TECHNICAL BULLETIN

INTRODUCTION OF DC TERMINAL COVER FOR PCR-SW-A1DC

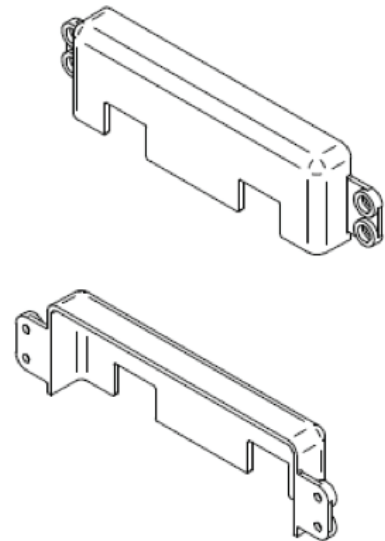
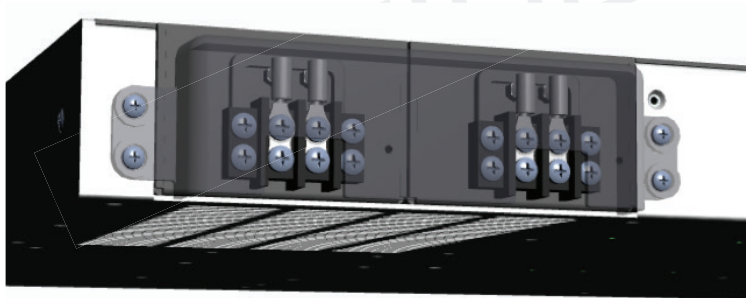
ATX is pleased to announce an improvement to the PCR-SW-A1DC Agile Frequency, Pilot Carrier Redundancy Source. All PCR-SW-A1DC orders placed after April 15th will come equipped with a protective cover for the DC power supply terminals.

All future orders of PCR-SW-A1DC Pilot Carrier Redundancy Source will ship with a clear plastic cover that protects the DC power supply terminals from accidental contact. The clear cover will provide visual access to the DC terminals while protecting a user from unintended contact. An opening in the cover still allows for intended access to the terminals.

This cover can be installed while the unit is running and will have no impact on the pilot signal.
